Thomastown DRAFT LAP Submission 2018

COMMENTS ON FLOODS, DROUGHTS and URBAN DESIGN

DETAIL of LAP Zone Map – (showing Tourism Objective in red)

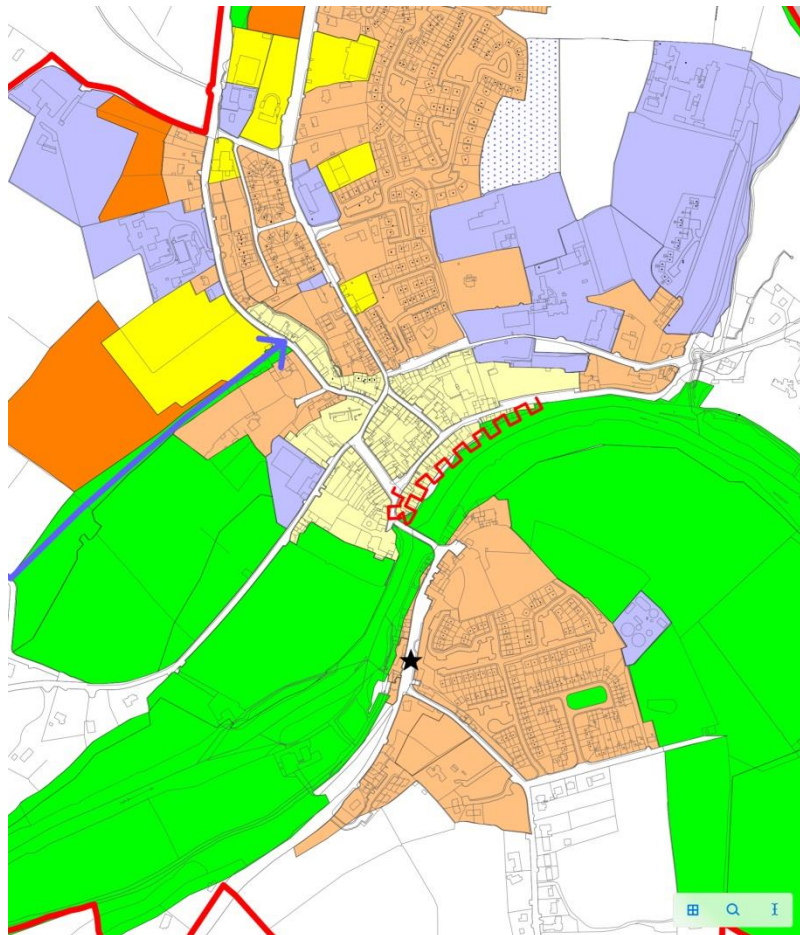
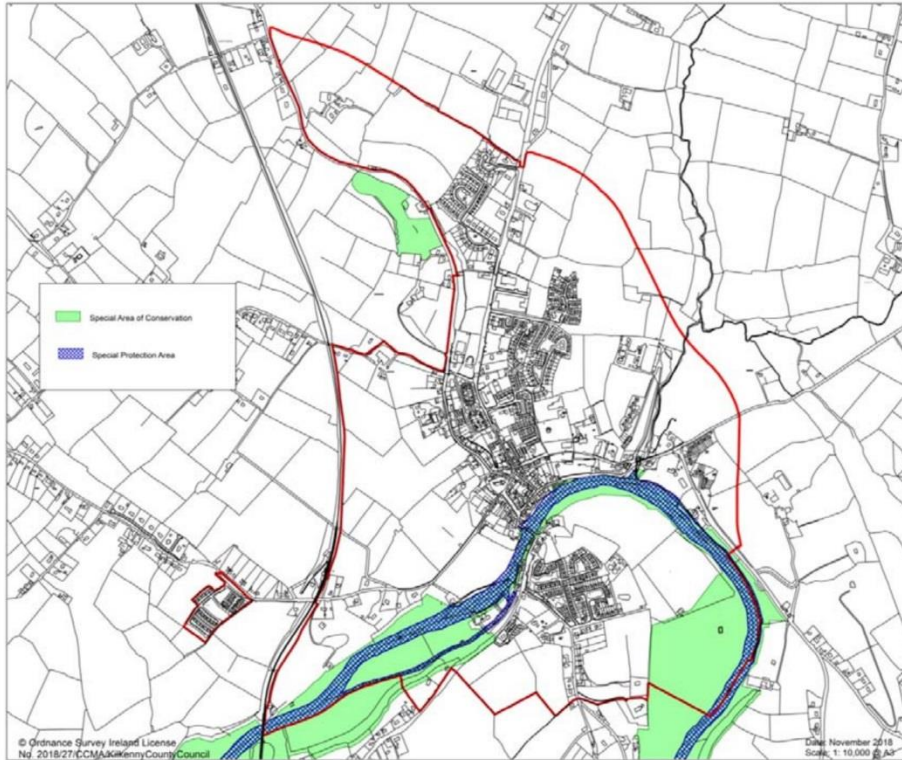
On cross referencing this document with the Draft LAP Zone Map and the LAP SPA and SAC Map, there appear to be contradictions in the placement of hard defenses and the objectives of the LAP.

It is in the interests of all sectors of the town from businesses, property owners, from the built & natural heritage, to be protected from the 1% AEP fluvial event as proposed by the OPW but **it appears that the placement and type of structures presented in the OPW plan contradicts the many objectives of the draft LAP** and the views many of the residents and specialist consultants in the town.

Proposal : It is proposed that consideration be given to the combination of defence mechanisms, such as hard defences - walls, embankments with natural defences, with the use of lakes/water reservoirs and natural barriers **being placed upstream from the town itself**.
